**Addendum No. 03.1****Issued: March 21, 2025**

Project Name: Brighton High School Teen Center  
Project No.: 2024516  
Bid Document Date: March 1, 2025  
Bid Package: NA  
Owner Name: Canyons School District

C1 FIRST FLOOR REFLECTED CEILING PLAN

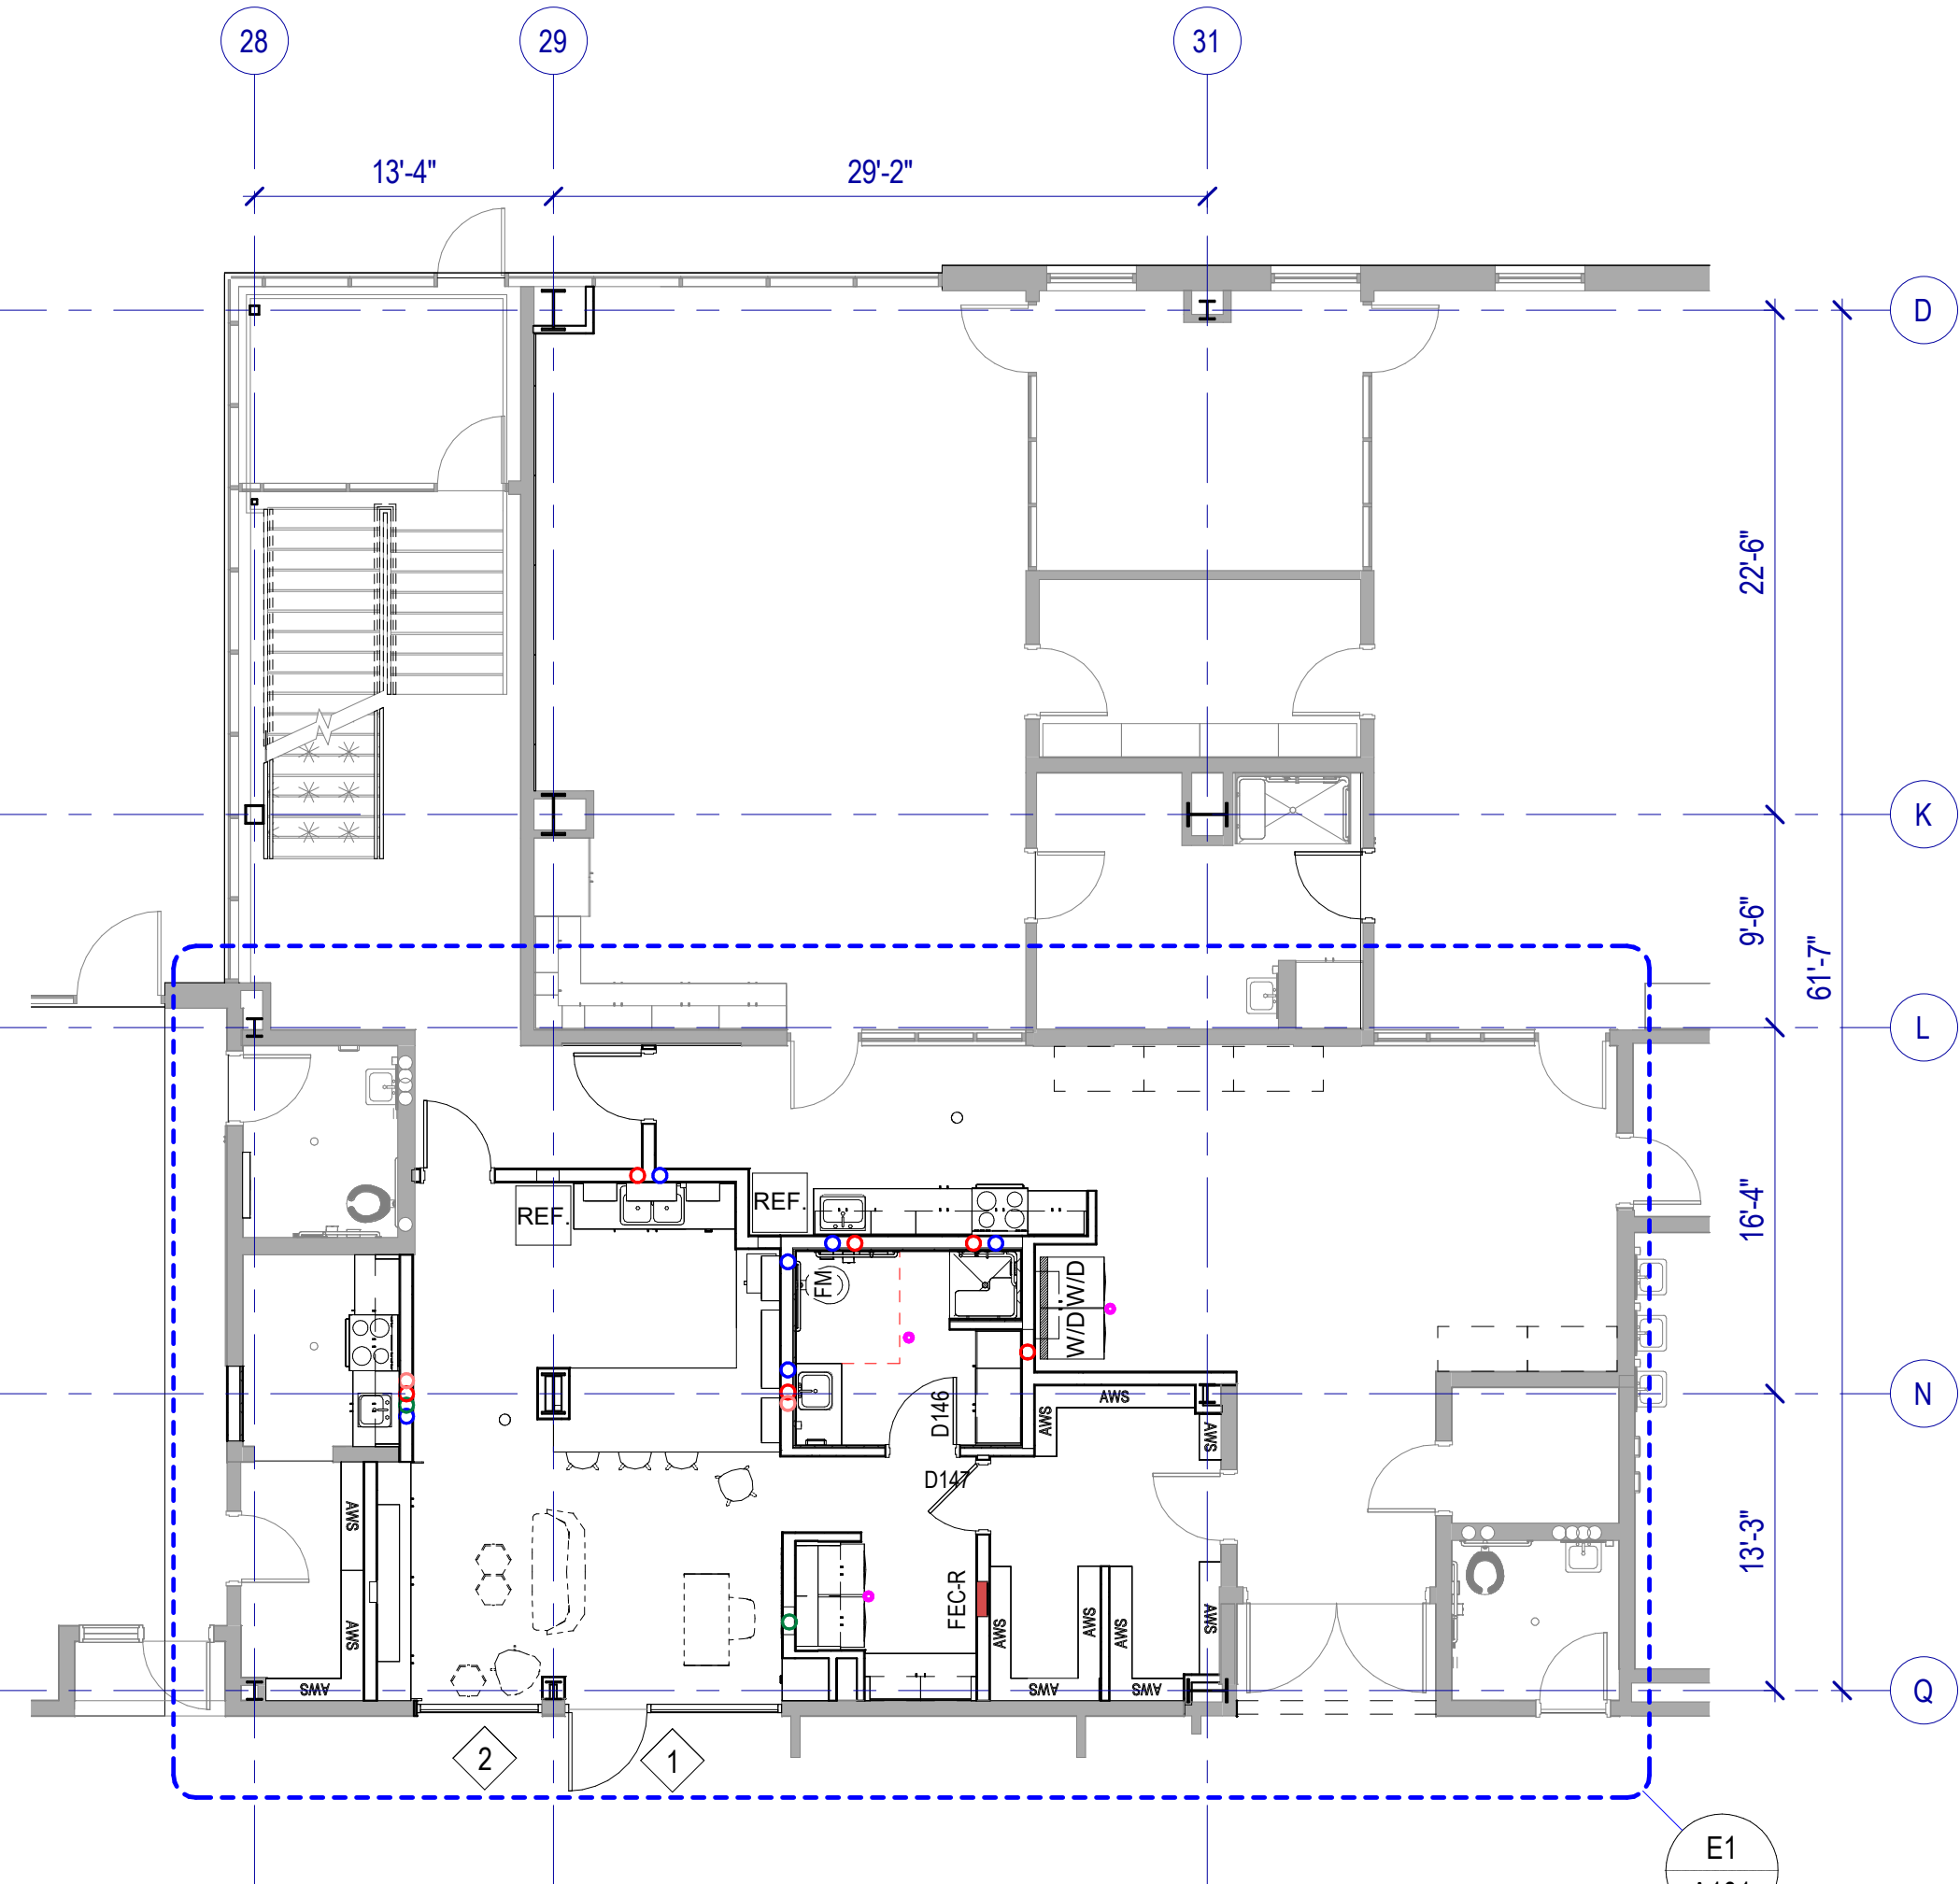
- Reflected Ceiling plan has been clarified to show hatch of existing ACP2 ceiling tiles.
- Door A103 has been clarified to show existing door to be reused.

**A410**

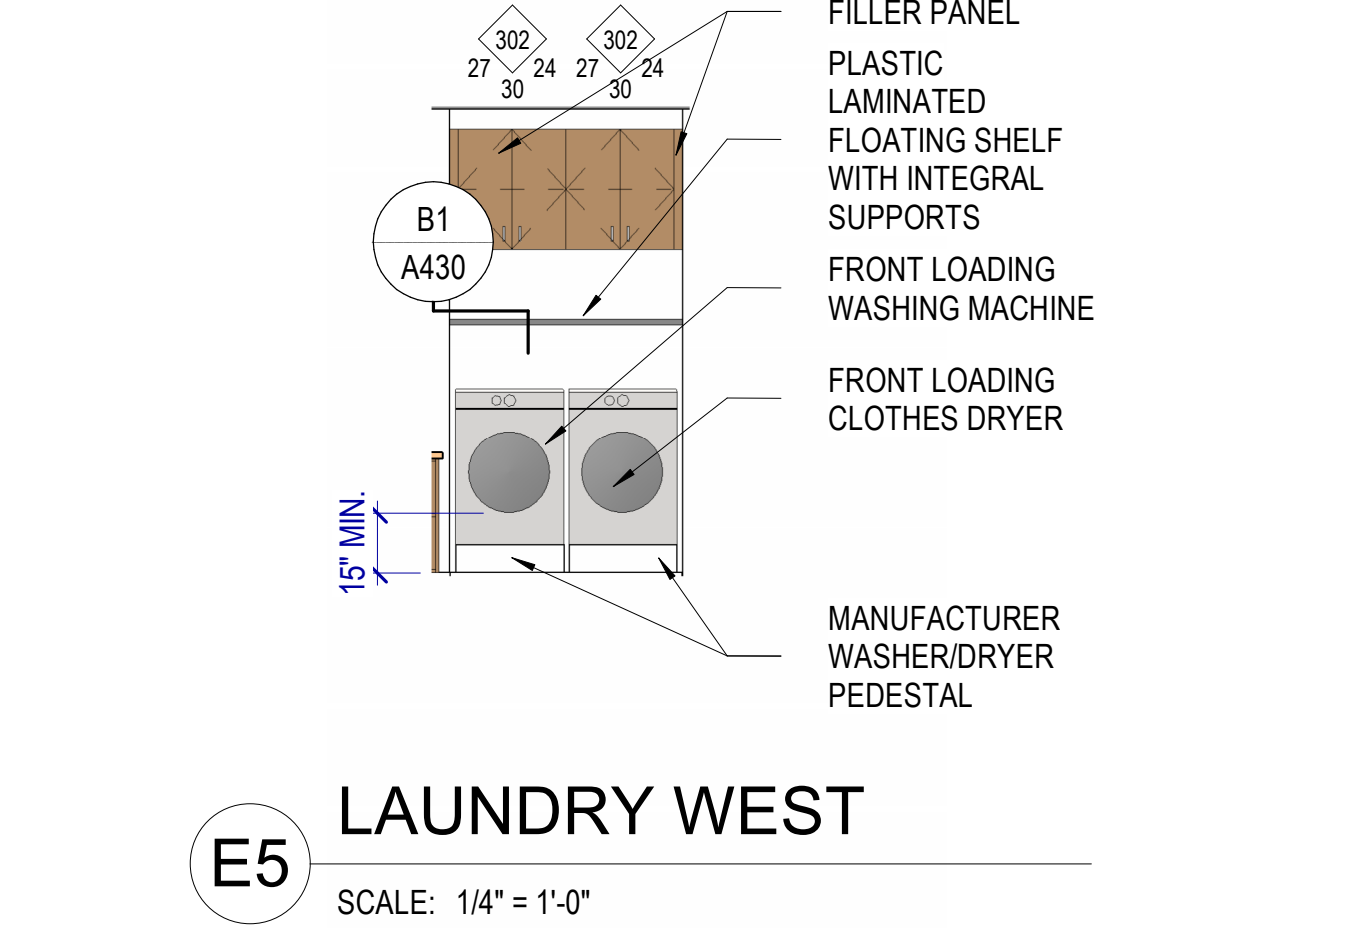
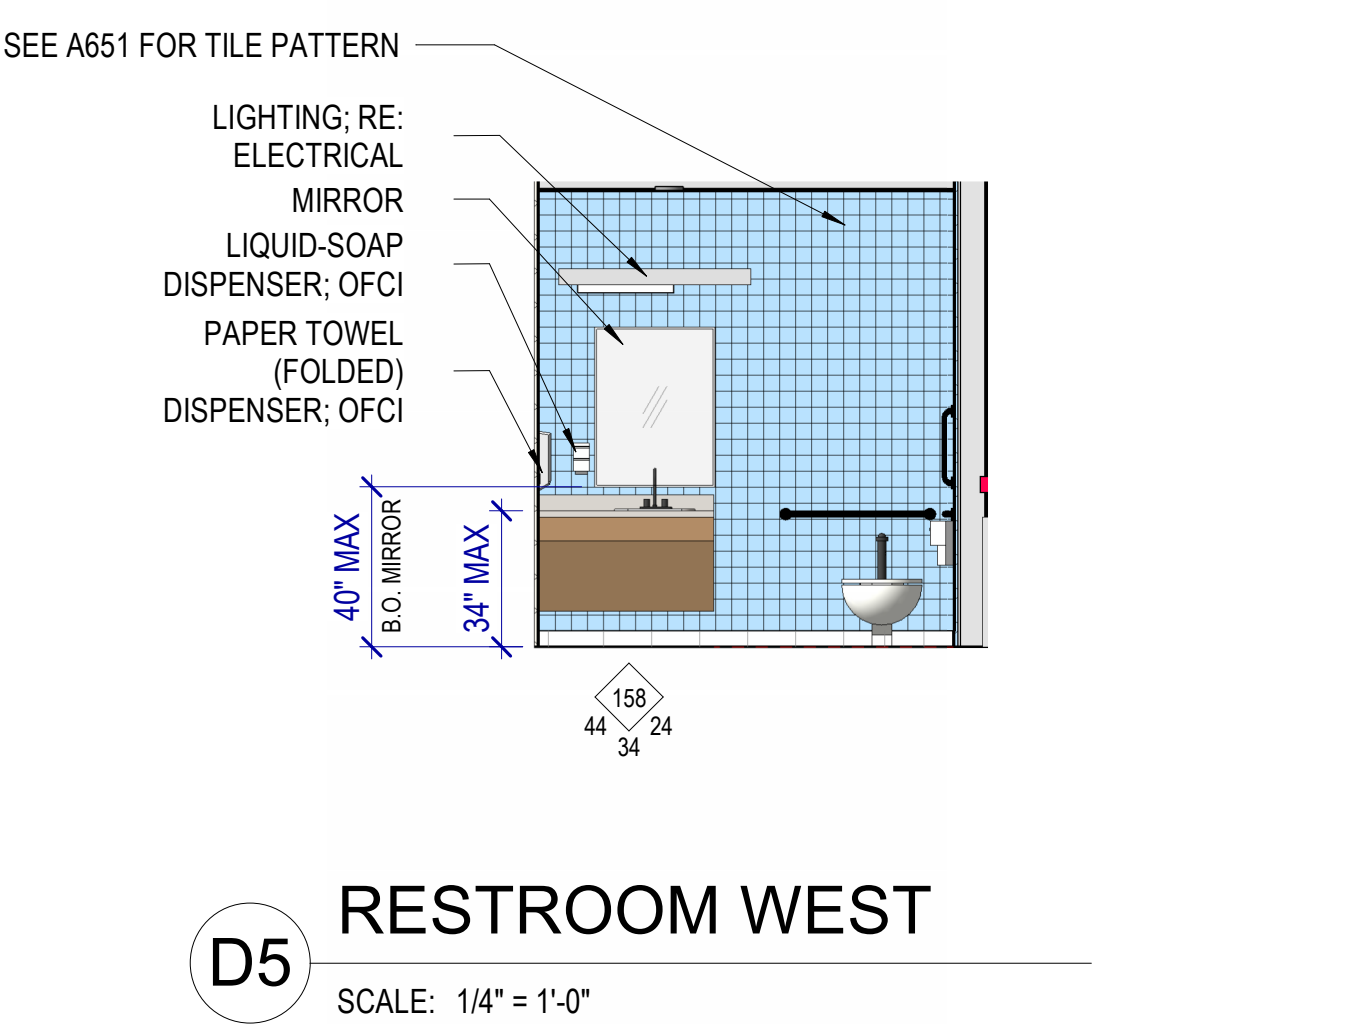
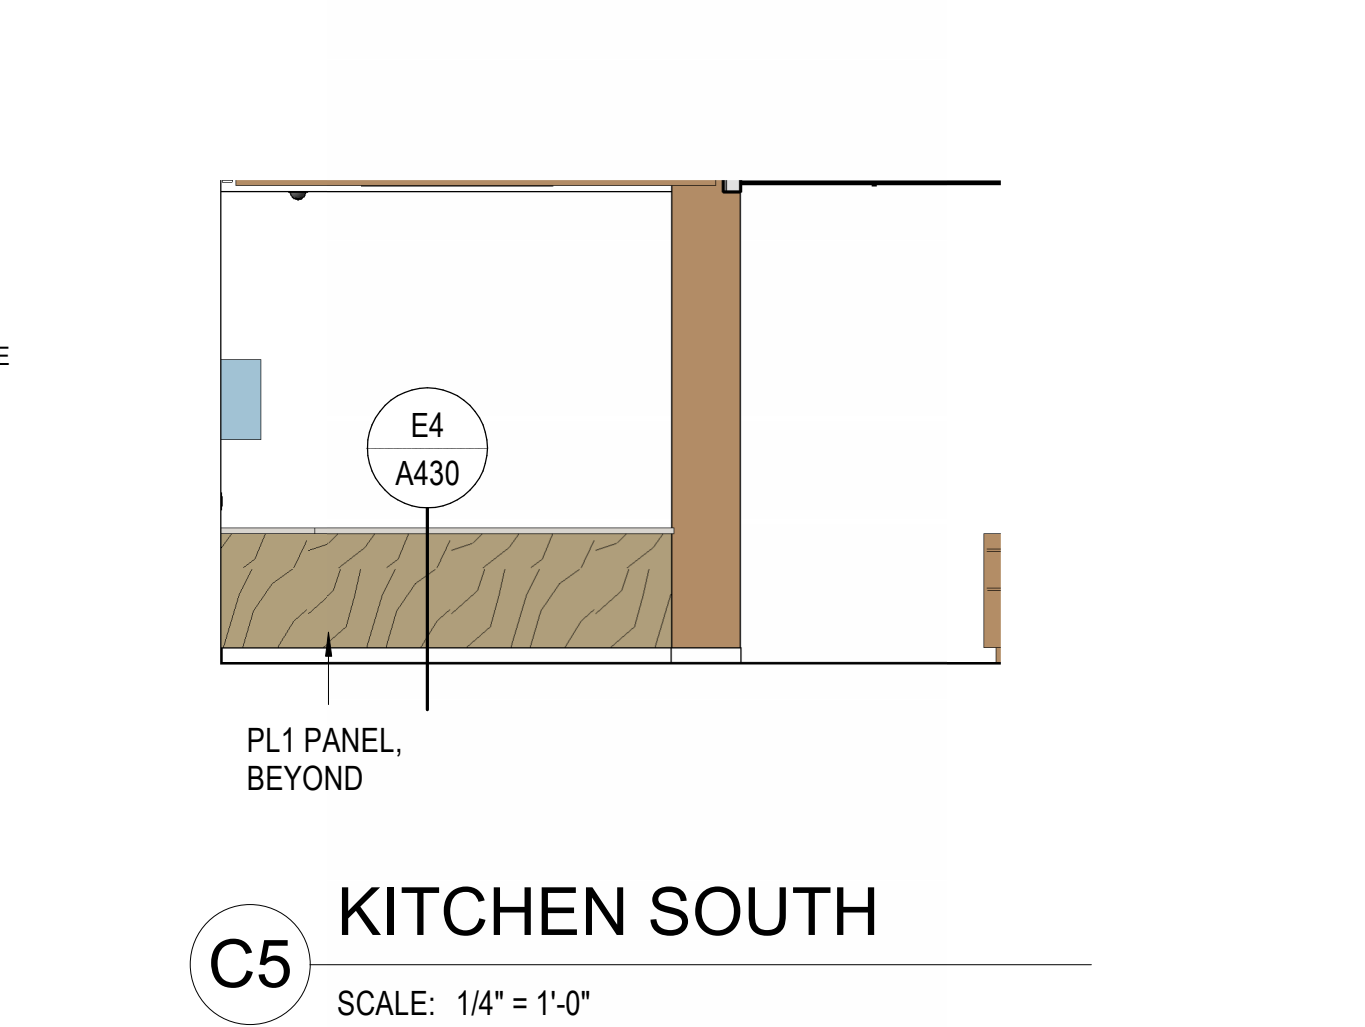
- Keynotes clarified to indicate filler panels to be used at cabinetry.

A1

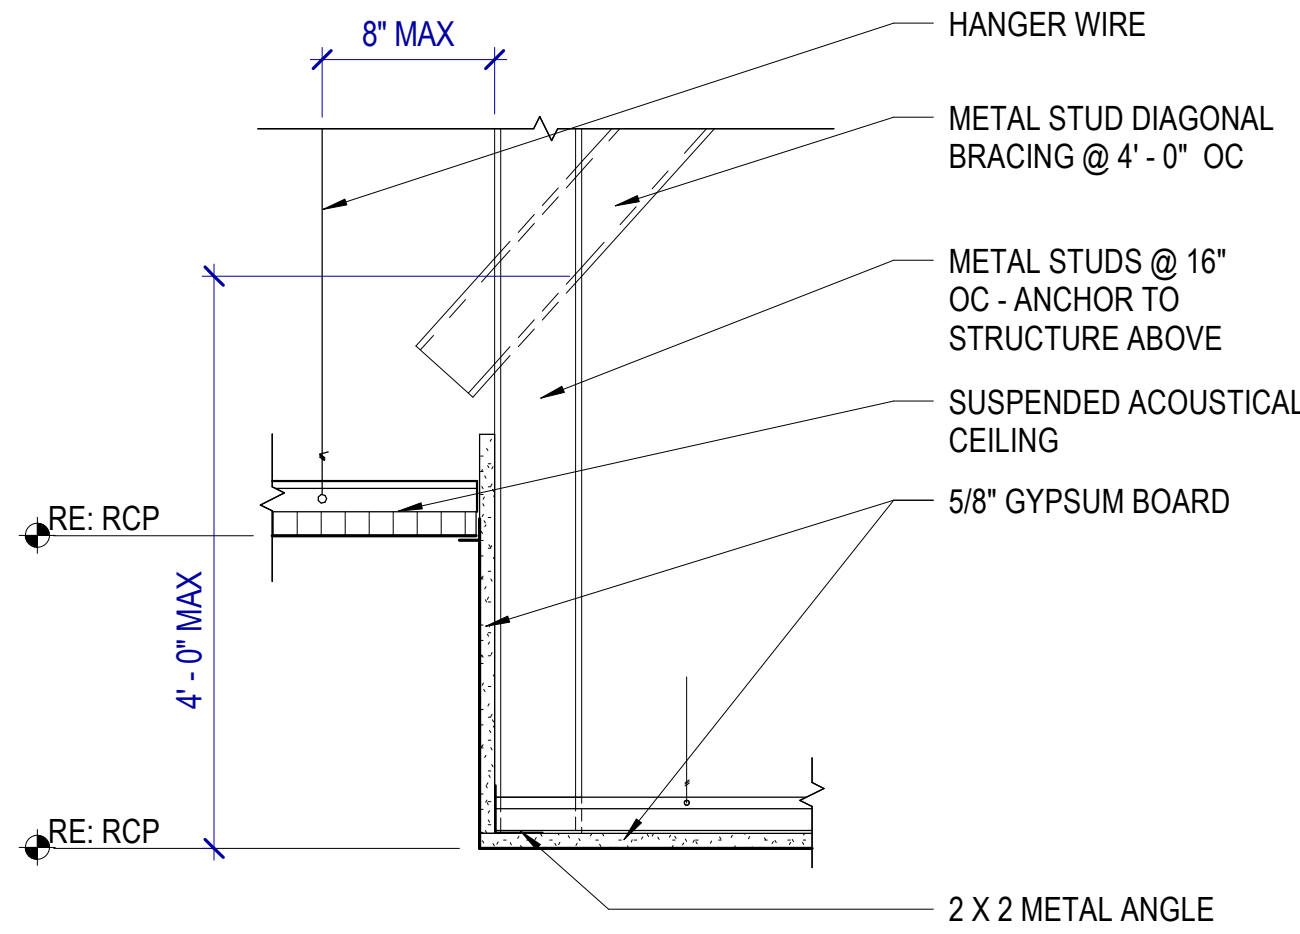
- Detail A2 has been omitted as it does not apply to the project.

NOT USED
